Riley Purgatory Bluff Creek Watershed District Permit Application Review

Permit No: 2021-063

Project: Reserve at Autumn Woods – The applicant proposes the construction of a new single-family residential subdivision project, underground utilities, associated roadways, landscaping, and stormwater management facilities. Stormwater management facilities include surface water detention basins, infiltration basins, and a vegetated swale to provide volume control, water quality, and rate control.

Reviewer: Dallen Webster E.I.T. and Scott Sobiech P.E., Barr Engineering

SKIMMER STRUCTURE WITH CAST IN FIELD CONCRETE BAFFLE WALL
 WETLAND D, OUTLET
 CHASKA, MINNESOTA
 SHEET NO. 570-18

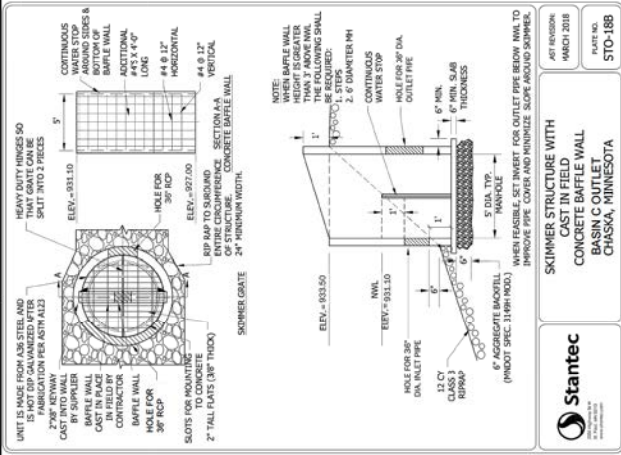
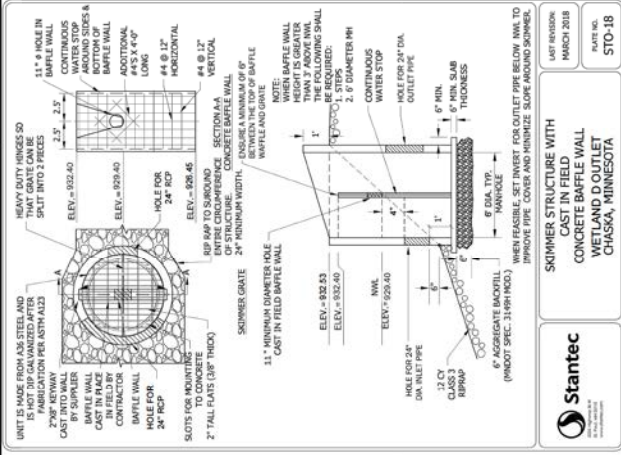
- The configuration of the proposed outlet structure for Wetland D was deemed necessary by the applicant to provide rate reduction to the standard of the City of Chaska, which requires a maximum discharge rate of less than 6 cubic feet per second (cfs) from Wetland D (0.2 cfs/acre). This discharge rate is significantly lower than the RPBCWD requirement to be less than the existing 100-year rate of 48 cfs. Because the proposed extended detention of stormwater in Wetland D helps reduce discharge velocities and associated erosive forces in the downstream watercourse, the proposed design provides better resource protection.

- The construction plans prepared by ISG Inc. include the installation of a skimmer structure for controlling flow rates from Wetland D to minimize disturbance and erosion of natural shoreline and bed resulting from peak flows.
